Answers to RC1:

Answers to RC2:

Answers to SC 1:

Answer to Editor:

Figure RA1: Relative to the mean raw 206/238 ratio) downhole fractionation trend for 3 different Carbonates and NIST 614 showing no consistent trend, making a downhole fractionation correction of unknown samples very difficult.

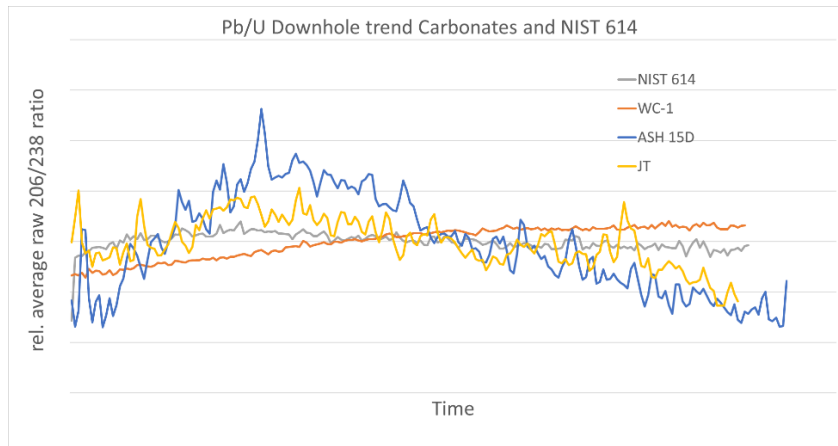
1. Downhole fractionation of NIST 614 and any carbonate material is not comparable, therefore, any attempt to correct a carbonate LA signals using NIST 614 can introduce systematic errors. Even the downhole fractionation trend between different carbonates can be different Fig. RA1

Figure RA2: Comparison of 10 JT ablation once integrated the whole signal (A) and once integrated to get max. spread of Pb/U ratios including multiple integration intervals per signal showing a clear improvement in precision. Colour code is the same ablation have the same colour.

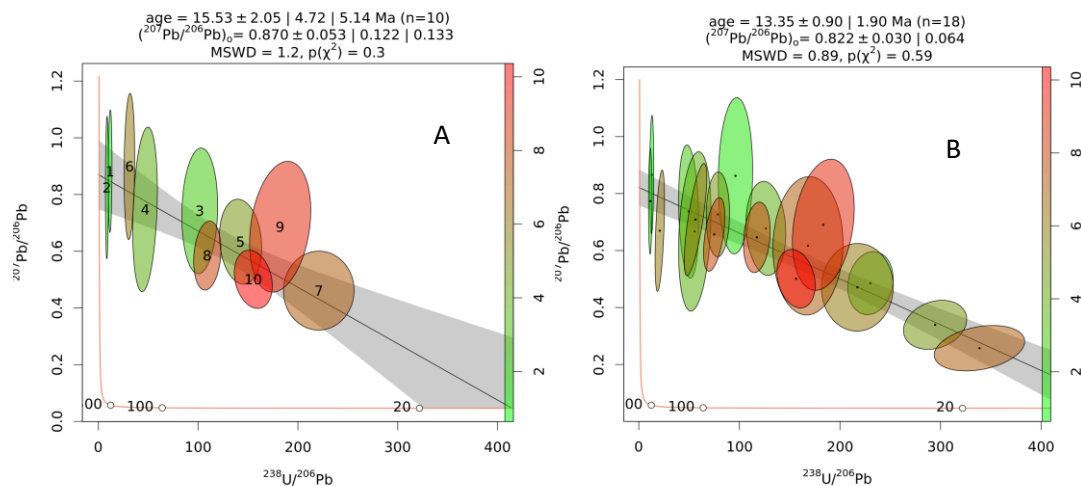
3. We agree that if all carbonates showed the same downhole fractionation pattern the approach to get best accuracy is to use exactly the same interval, but due to heterogeneity in ablation rate, within-run variations in initial Pb, U content, and age variations this is hardly possible: a comparison for one piece of JT (10 ablations) is presented comparing total integration with selective and multiple integrations. Fig. RA2

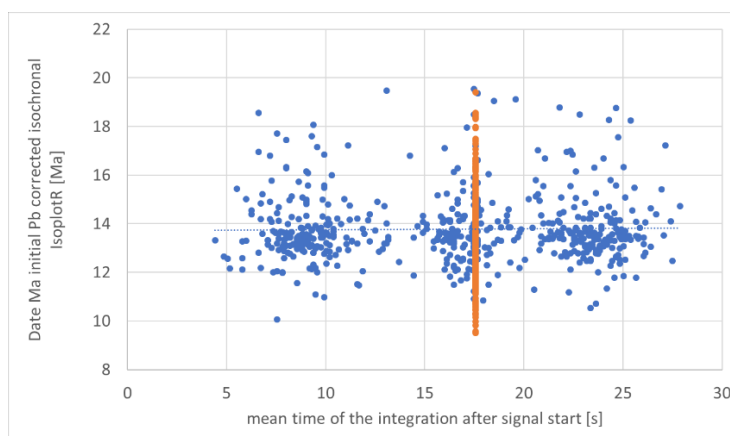
6. We agree on the referee’s point that the “adjustments were random enough not to make enough of a difference in the final age”. We also agree that it can be possible by selecting only later parts of the signal, the final age will get older respectively younger when only the first parts of the signal are selected. However, the new data of JT, for which we systematically investigated this effect, does not show this behaviour, although data on e.g WC-1 with a clear increasing downhole fractionation trend (Fig RA1) will certainly show this effect. Fig. RA3

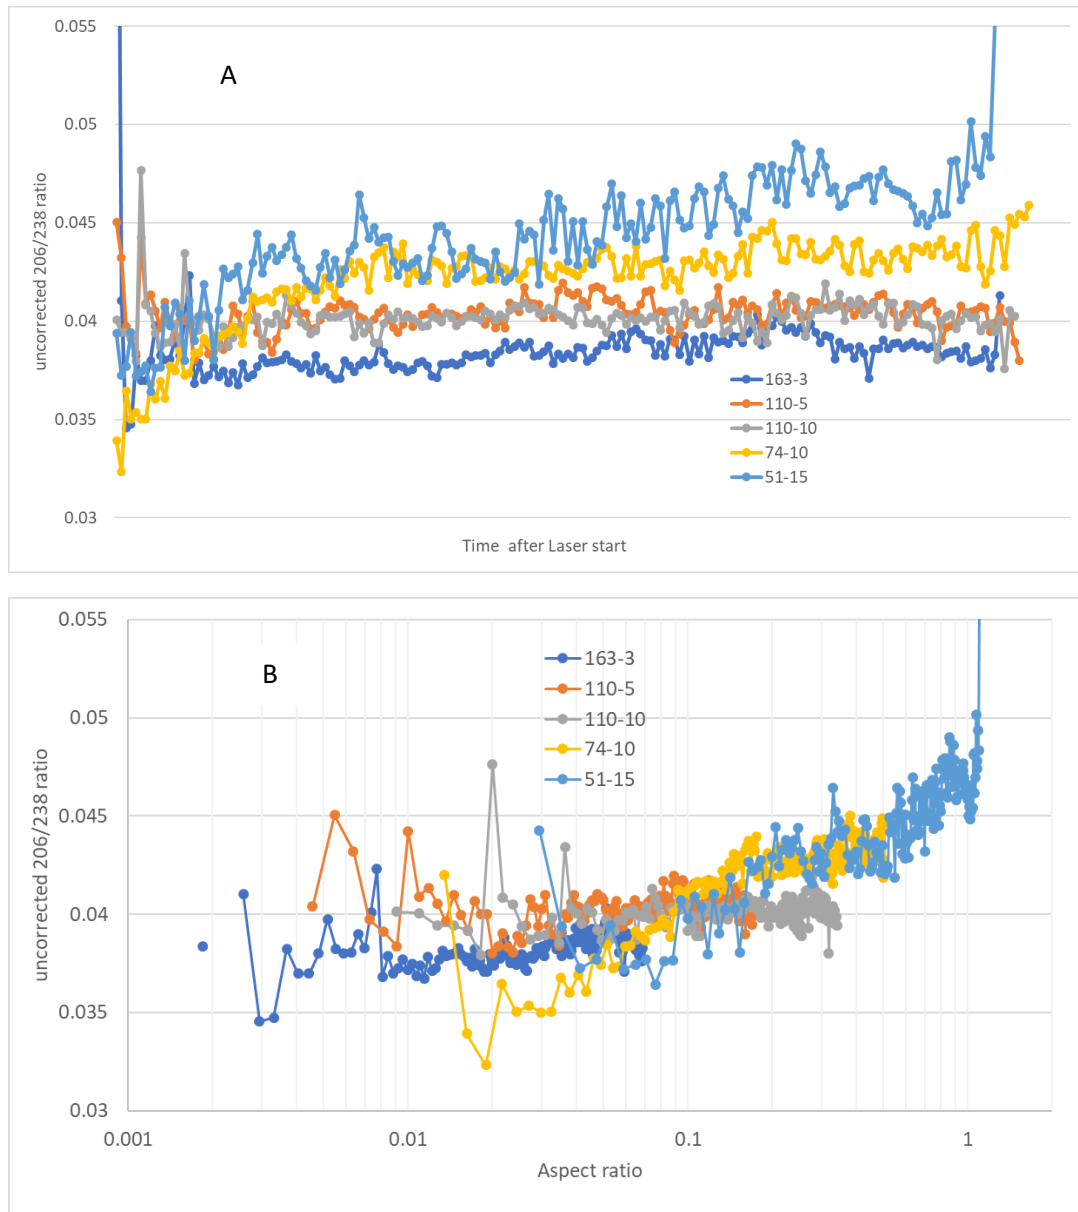
7. Figure RA4: shows the downhole trend of WC-1 for different aspect ratios (mean of $n > 15$ signals) both comparing vs time (A) and vs the estimated aspect ratio (B). This figure shows that up to an aspect ratio of 0.2-0.3 no clear downhole trend is observed and only for higher aspect ratios the Pb/U increases significantly.

Therefore, we changed the description accordingly: “The selection of different integration intervals along a single hole ablation can introduce systematic offsets if not randomly distributed due to different amounts of downhole fractionation between RM and sample if there is significant amount of downhole fractionation in either the RM and/or the sample. Best practice is to use as good as possible the same integration intervals with respect to crater shape for both
